Palisades Nuclear Plant
Docket 50-255
License No. DPR-20

NMC Response to NRC Requests for Additional Information Dated June 22, 2005
Relating to License Renewal for the Palisades Nuclear Plant

**NMC Responses to NRC Requests for Additional Information (ML051730291)
Dated June 22, 2005**

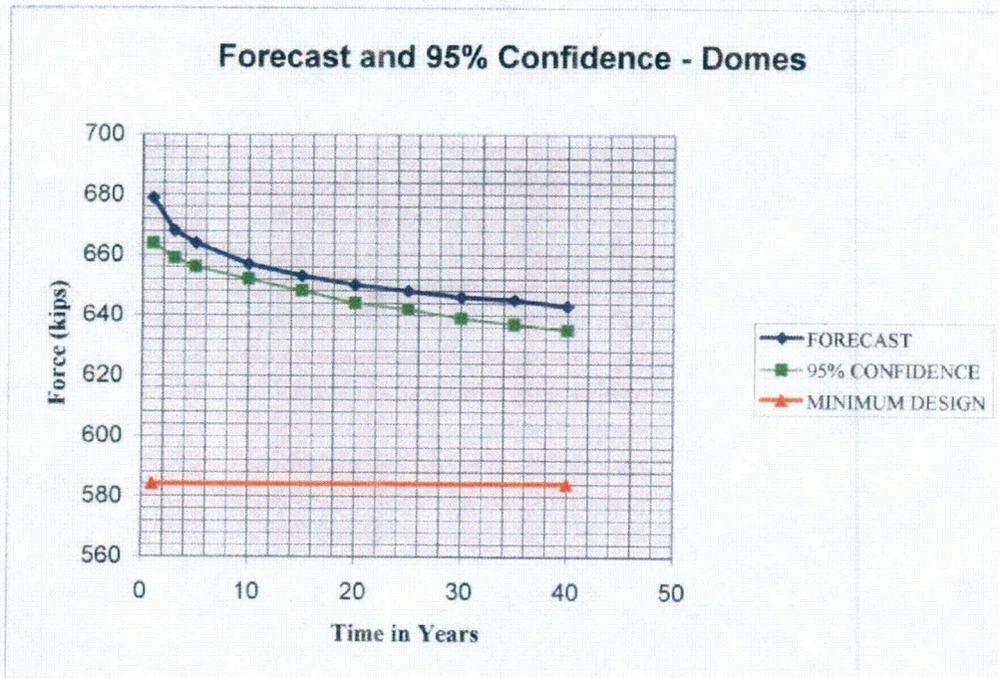
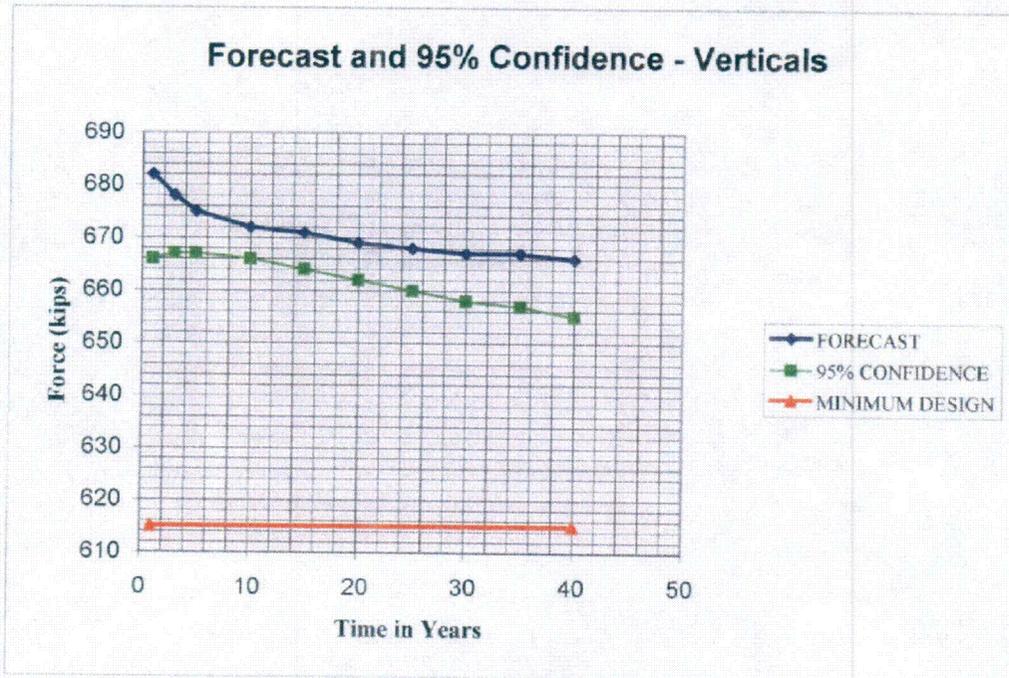
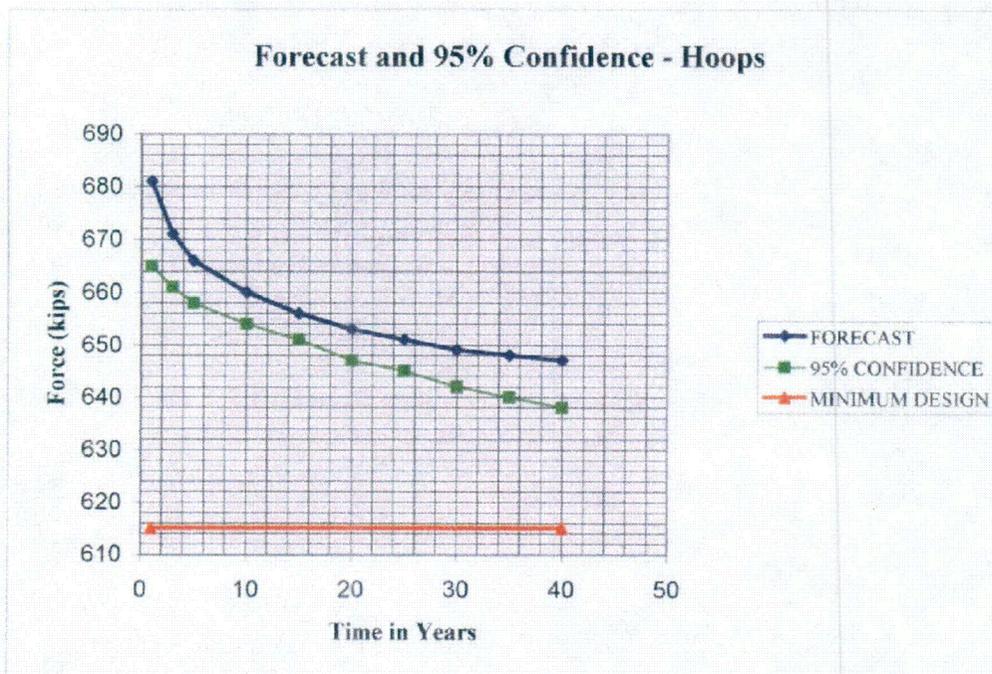
In describing the scope of the program related to NUREG-1801 AMP X.S1, in AMP B2.1.7, the applicant states: "The pre-stressing force in the common tendon is measured during each surveillance and is used to establish the trend of pre-stressing loss of the group." This practice is not consistent with AMP X.S1 and NRC's Information Notice (IN) 99-10, "Degradation of Pre-stressing Tendon Systems in Pre-stressed Concrete Containments." The information notice recommends the use of all available measured pre-stressing forces for developing trend lines for each group of tendons. As Palisades started using random sampling of tendons since 15th year surveillance of tendons (FSAR Section 5.8.8.3.3), the applicant has at least three sets of measured pre-stressing forces for performing regression analyses and developing trend lines. The applicant is requested to provide trend lines for each group of tendons for comparison with the predicted lower limits (PLLs) and the minimum required values (MRVs). The applicant is also requested to provide a tabulation of the measured pre-stressing forces (not individual wire forces) used in the corrected regression analyses.

Regression analysis results are contained within Precision Surveillance Corporation (PSC) report entitled, "30th Year Physical Tendon Surveillance of Palisades Nuclear Plant, 2002." The discussion is contained in Section VIII, "Comparison with Original Installation Data" (attached to this letter as Enclosure 4).

A regression analysis was conducted on each of the tendon groups and the graphs are shown on the following pages along with the input data for force, test dates and age (time stressed). All three analysis show each group remaining above the minimum requirements well beyond the next surveillance period. Projections to 40 years after installation (38 years of plant life) show a dome projection of 643 kips with a minimum requirement of 584 kips, vertical value of 666 kips against a minimum requirement of 615 kips and a horizontal projection of 647 kips against a minimum of 615 kips. As a result of the generator change and the retensioning of a large number of vertical tendons these must now be excluded from this analysis. This results in only two data points each for the Twentieth and Twenty-fifth year surveillances leading to a somewhat erratic forecast profile. With only two points to plot the projection does not have enough points to provide extensive indications of trend at this time. However, a review of losses for the vertical group do not give any indication of group deterioration and there is little doubt that the group will remain above minimum values throughout the next surveillance interval. Dome and horizontal tendons show forecast curves consistent with input from a larger field of data and will also remain above minimum levels beyond the next surveillance.
